Focused Review of Specific Remediation Issues

An Addendum to the Remediation
System Evaluation for the
Homestake Mining Company (Grants)
Superfund Site, New Mexico
Region 6

Final Report
December 23, 2010

Prepared by US Army Corps of Engineers
Environmental and Munitions Center of Expertise
For US Environmental Protection Agency, Region 6

Figure 1b. Well Locations

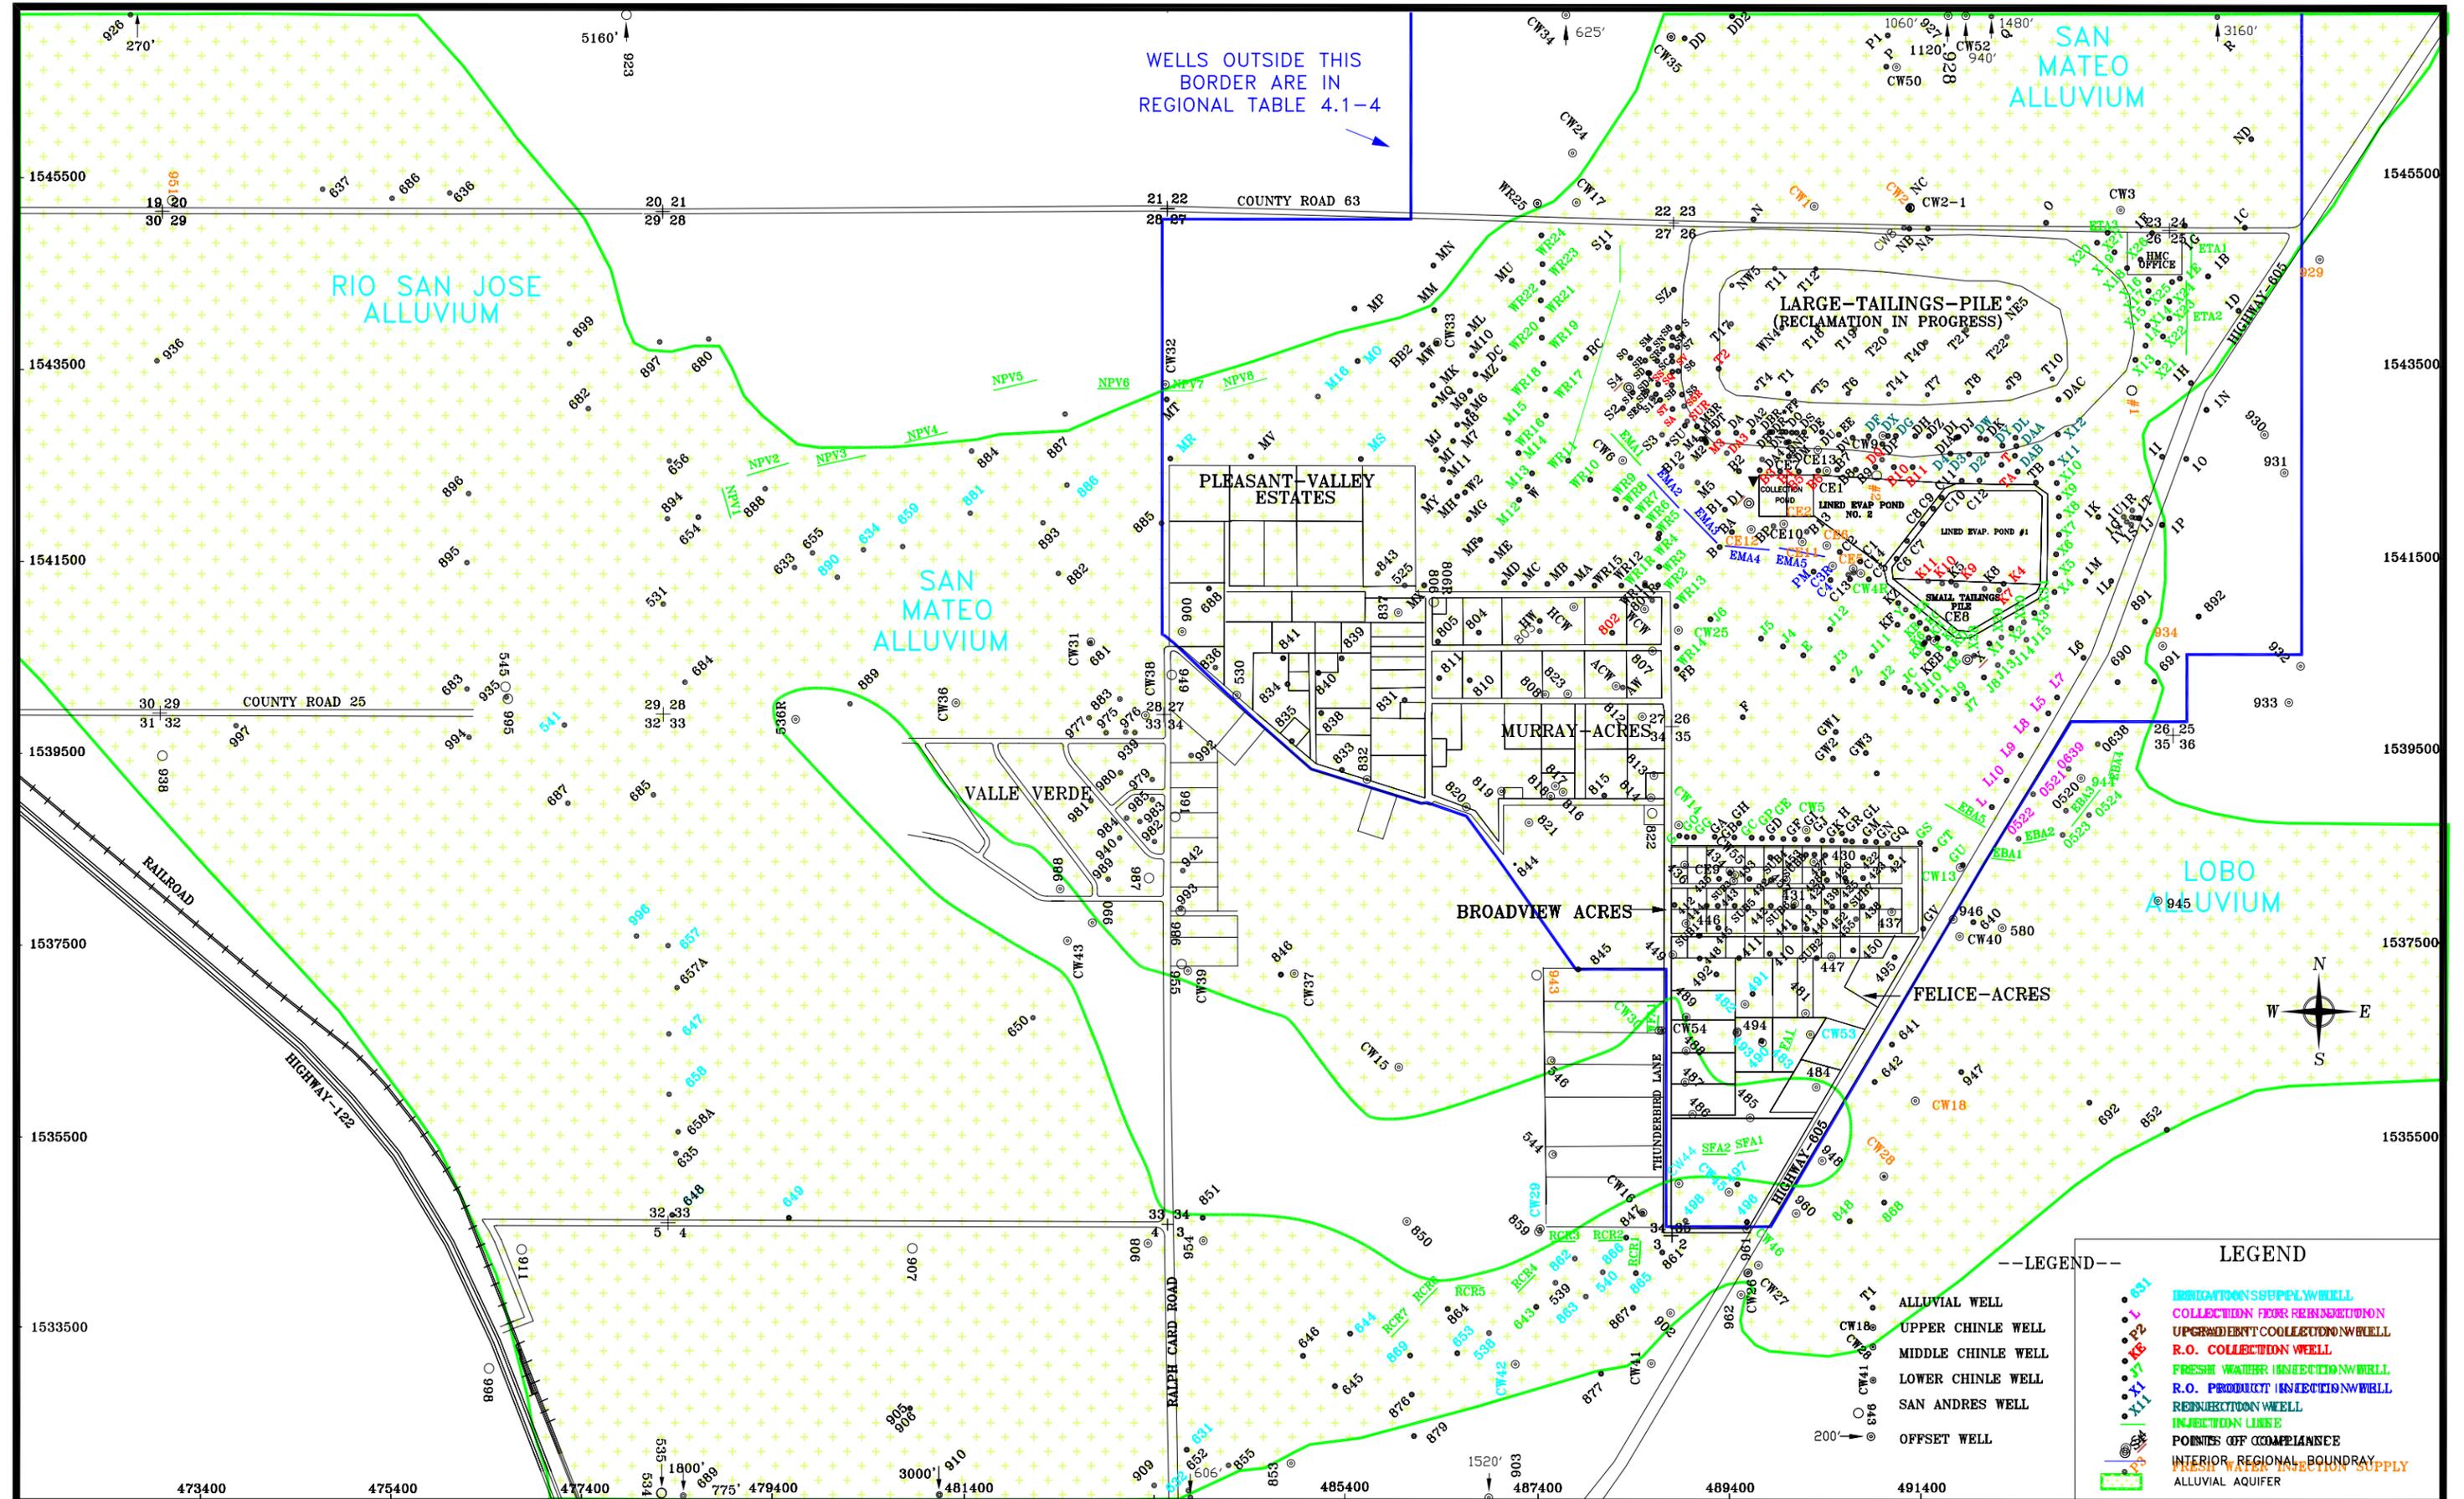
89	EPA	Figure 1	9	Add a figure that clearly indicates monitoring well locations. I can not identify monitoring wells referenced in the report on this figure.	Concur	We will attach a separate file in 11x17" format such that it can be more easily read.
90	EPA	Figures	11	Please check the labels on the x and y axes – the dates and other units are not correctly located or easy to read. Please reformat figures to allow for accurate reading of the x and y values.	Concur	Text will be revised.
91	EPA		17	last paragraph, 3 rd sentence. Change 'has' to 'have' and change figure to "Figure 15 in the same sentence.	Concur	Text will be revised.
92	EPA		18	paragraph in the middle of the page regarding additional testing of oxidation-reduction potential. Please elaborate on the types of add'l testing that would be necessary and how the data should be interpreted.	Concur	We will elaborate to indicate that downhole ORP and pH measurements would be useful to assessing the likely state of the U in the pile and the impacts from the flushing program on the stability of the U.

9. page 7, section 2.2.1, first sentence. Change ‘human’ to humans”
10. page 7, section 2.2.2, first sentence. Change ‘and’ to ‘can’.
11. page 9, Figure 1. Add a figure that clearly indicates monitoring well locations. I can not identify monitoring wells referenced in the report on this figure.

Figure 1 at p. 9 is not sufficiently detailed to identify the location of the wells of concern discussed in this section, as well as other sections of the Report. Figure 1 does not identify the locations of wells DD or S11 or the flow paths of concern on the west side of the tailings pile.

Neither Figure 1 nor other figures identify the location of fault zones in the project area, the extent of the alluvial aquifer, or other geologic features that might influence ground water flow paths on the west side of the large tailings pile. The “scanned” well location maps posted by the RSE contractor team on the HMC RSE Quickr website provide additional detail but are not clearly integrated into the DRSE Report.

The DRSE Report should be supplemented to address the location of well DD and its associated flow path within the footprint of proposed evaporation pond 3 (neither well DD or EP3 are identified on Figure 1) and the challenges to investigation and remediation of the ground water with rising uranium content in the well DD/well S11 area north and west of the large tailings pile.

Figure 3. Well X Uranium Concentration Trends.

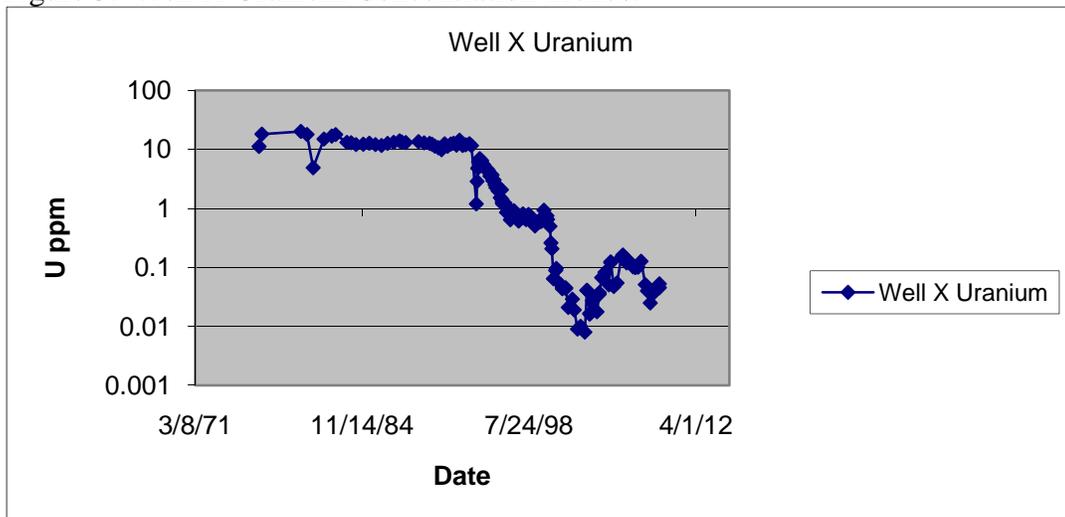
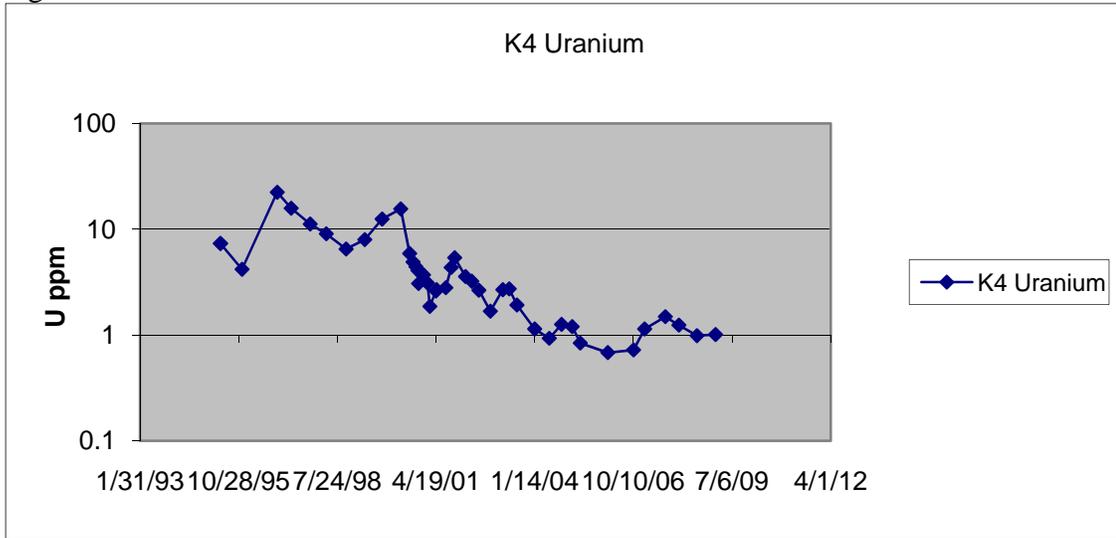
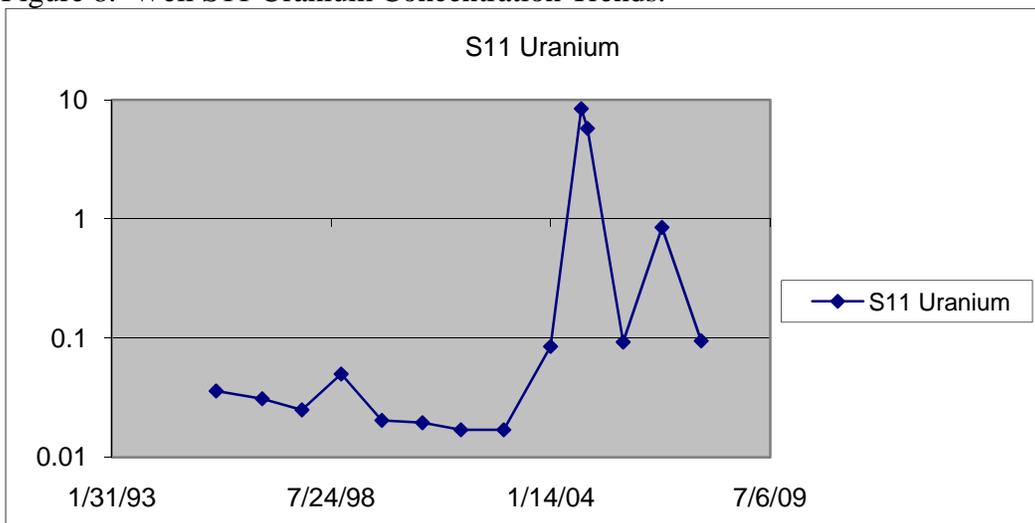
53	NMED	2.3	7	The last sentence should refer to figure 2 instead of figure 1.	Concur	The text will be corrected.
54	NMED	3.2	8	Please move x-axis label to the bottom of figures 3, 4, and 8.	Concur	The readability of the charts will be improved in several ways.

2.3	The last sentence should refer to Figure 2 instead of Figure 1.
3.2	Please move x-axis label to bottom of figures 3, 4, and 8.
3.6	The San Andres aquifer is an important municipal water supply source to the nearby major population centers of Grants, Milan, and Bluewater, as well as to residents using private wells within the impacted subdivisions south of the Site. NMED asserts that routine and focused monitoring of this aquifer, both upgradient and downgradient of the Site, should be included within the Remedial System to better support an assertion of no contaminant impacts to this aquifer from the overlying Site-contaminated aquifers.

Figure 3 on p. 8 illustrates the downward uranium trend in well X.

Review of the uranium concentration trend for well X in Figure 3 shows that the uranium concentration in the well remained relatively steady for several decades before a steep drop in uranium concentrations was detected.

Figure 3 shows the drop in uranium concentration occurring after the construction of EP1 and the injection wells – including the "1993 J-line" of injection wells – along the south perimeter of EP1 and the small tailings pile. Figure 1 shows well X to be in such close proximity to injection wells that the symbols for the two are touching on the figure.

Figure 14. Uranium Concentrations in Large Tailings Pile

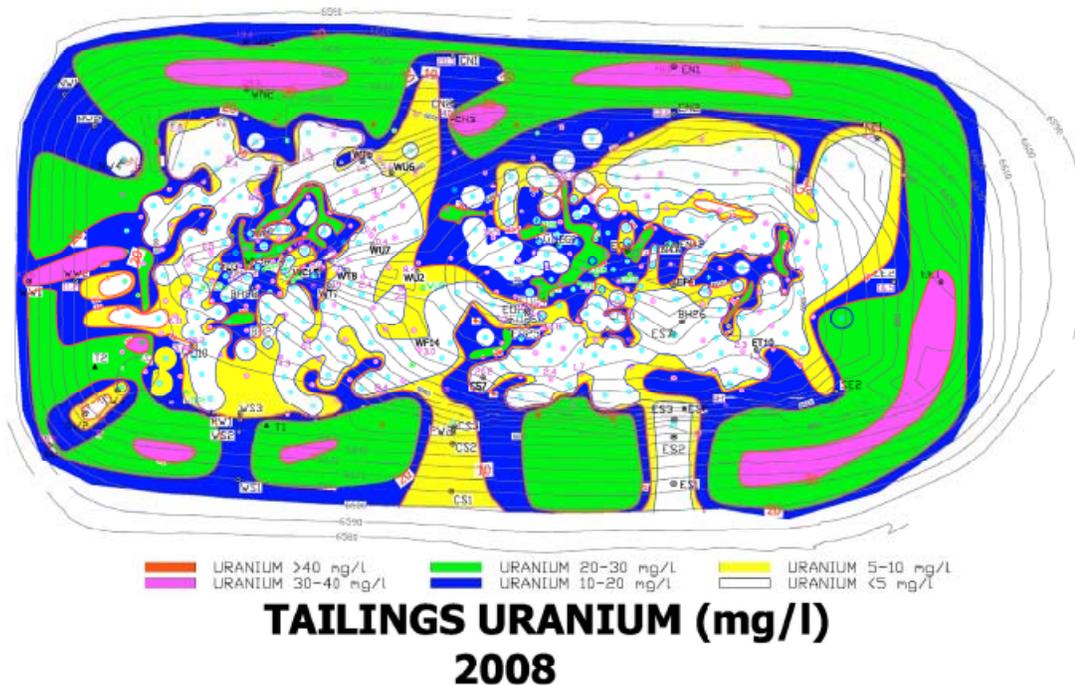
34	HMC	4 & Fig. 14	17	<p>The flushing of the large tailings pile is discussed and Figure 14 is used to show the 2008 uranium concentrations in the tailings. Although the ACOE uses this figure to show the variability of uranium in the pile and illustrate their belief that the flushing has not been effective, HMC believes that the flushing has been effective at removing uranium mass. This is demonstrated by comparing the 2000 and 2009 maps for uranium in the tailings pile, which shows that a significant amount of uranium has been removed. See also HMC's response to Recommendation No. 2 for additional evidence of the effectiveness of the flushing and extraction program. Below is the 2000 uranium concentration map for the tailings pile showing uranium concentrations exceeding 30 mg/L in much of the pile. Also below is a map of the 2009 uranium concentrations in the pile, which illustrates the significant reduction in concentrations resulting from the flushing and extraction program. For 2009, approximately 67.5 percent of the west side slime area has uranium concentrations less than 5.0 mg/L, and 45.5 percent of the same area has concentrations lower than 2.0 mg/L.</p>	Non-concur	<p>The flushing program has made some progress, as the report acknowledges. As discussed above and in the report, the concern is that the long screens of the monitoring points makes it likely that injected water has impacted the monitoring point, but that the ambient concentrations may much different. The map was meant to illustrate the wide variations in concentrations at closely spaced points such that the flushing is clearly not uniform.</p>

Section 4.1 and Figure 14, Flushing of Large Tailings Pile; page 17. The flushing of the large tailings pile is discussed and Figure 14 is used to show the 2008 uranium concentrations in the tailings. Although the ACOE uses this figure to show the variability of uranium in the pile and illustrate their belief that the flushing has not been effective, HMC believes that the flushing has been effective at removing uranium mass. This is demonstrated by comparing the 2000 and 2009 maps for uranium in the tailings pile, which shows that a significant amount of uranium has been removed. See also HMC’s response to Recommendation No. 2 for additional evidence of the effectiveness of the flushing and extraction program. Below is the 2000 uranium concentration map for the tailings pile showing uranium concentrations exceeding 30 mg/L in much of the pile. Also below is a map of the 2009 uranium concentrations in the pile, which illustrates the significant reduction in concentrations resulting from the flushing and extraction program. For 2009, approximately 67.5 percent of the west side slime area has uranium concentrations less than 5.0 mg/L, and 45.5 percent of the same area has concentrations lower than 2.0 mg/L.

Figure 15. Uranium Concentrations in Select Wells in a) Western Large Tailings Pile and b) Eastern Large Tailings Pile.

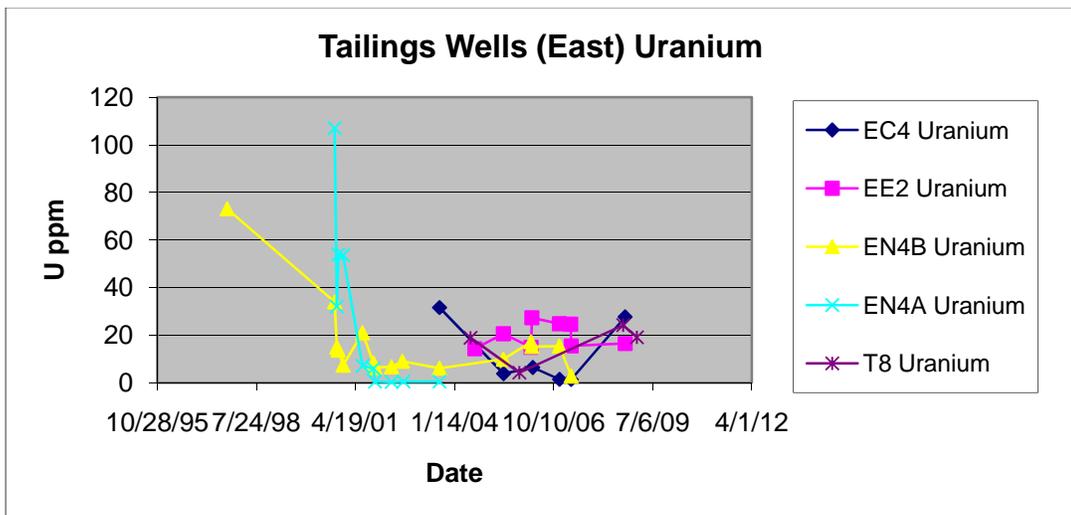
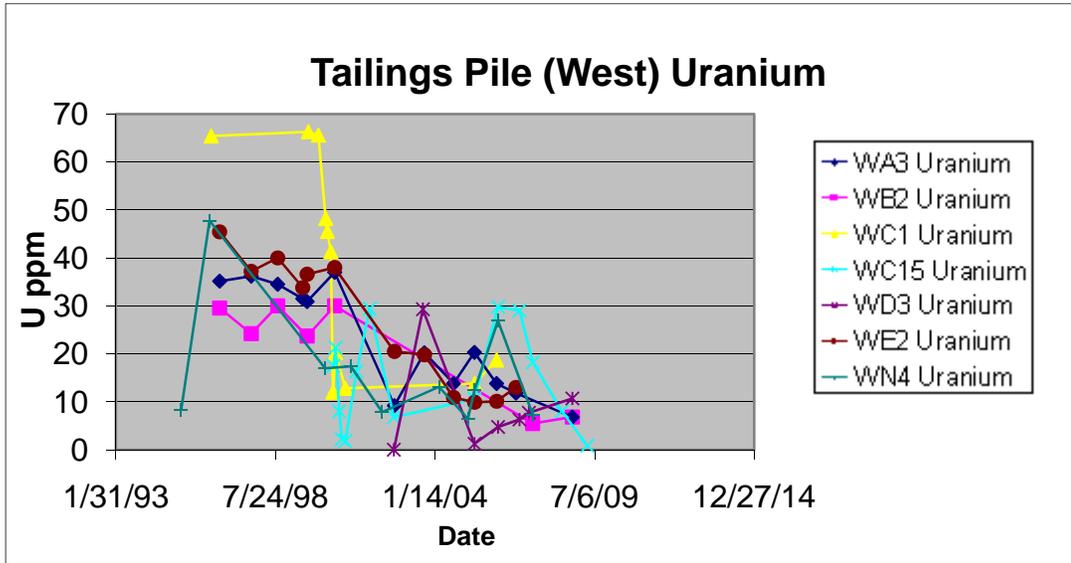
57	NMED	4.1	18	<p>Tailings in Figure 15 is misspelled.</p>	Concur	<p>Chart heading will be corrected.</p>
